AR-07-0302

Southern Nuclear Operating Company
Vogtle Early Site Permit Application
Safety Review Site Audit Hydrology Information Needs

NRC Hydrology Information Needs

Vogtle ESP Application

Item #1 Figure 1

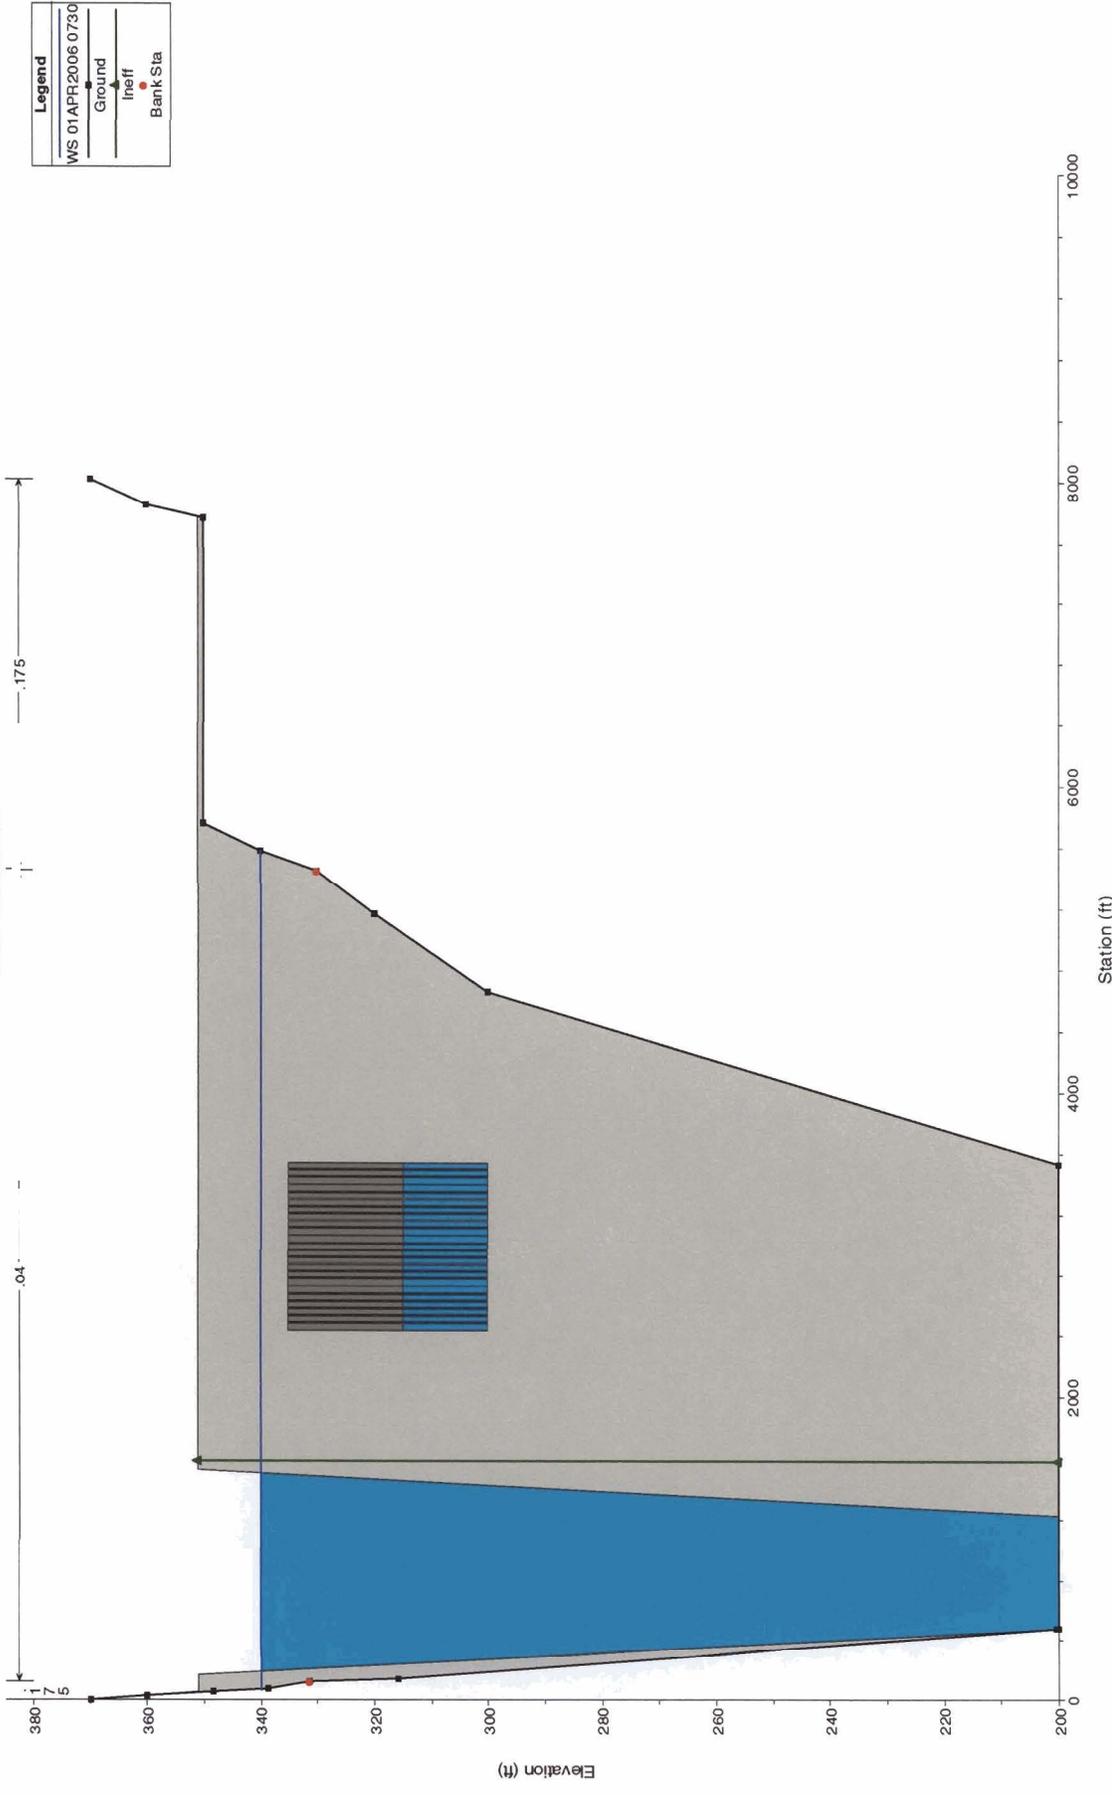
Item #1 Present the calculations used to estimate the dam breach parameters discussed on page 2.4.4-4 and outlined in the USBR.

- 2) As shown on Item #1 Figure 1 of this response, the total dam width at the top of the dam is about 5,700 ft. (Reference 2). The width of the dam at the upstream invert elevation (El. 200 ft) is about 2,840 ft. Located within the portion of the dam that extends to El. 200 ft is a concrete embankment section 2,282 ft wide where the tainter gate spillways and powerhouse are located (Reference 2). The failure mode assumes that only the earth section of the dam will erode during the breach. Consequently, the 755-foot bottom width of the breach extends beyond the area in which the actual ground elevation is at the minimum ground elevation of El. 200 ft.

- 3) Superposing the 755-foot bottom width at El 200 ft on the cross-section of the valley on the upstream side of the dam shows that more than 200 feet of the breach would be above El. 200 ft. Therefore, the entire bottom of the breach was taken as El. 200 ft to be conservative. The cross section shown in Figure 1 has been artificially widened at El. 200 ft to accommodate the 755 ft wide breach.

Based on a review of data and analyses for 84 dam failure cases, and the physical layout of J Strom Thurmond Dam, a breach width of 755 ft, with 2 to 1 side slopes was selected for this analysis. Additionally, most of the breach time predictions are close to 1.0 hour. Thus, a breach time of 1.0 hour was selected for this analysis.
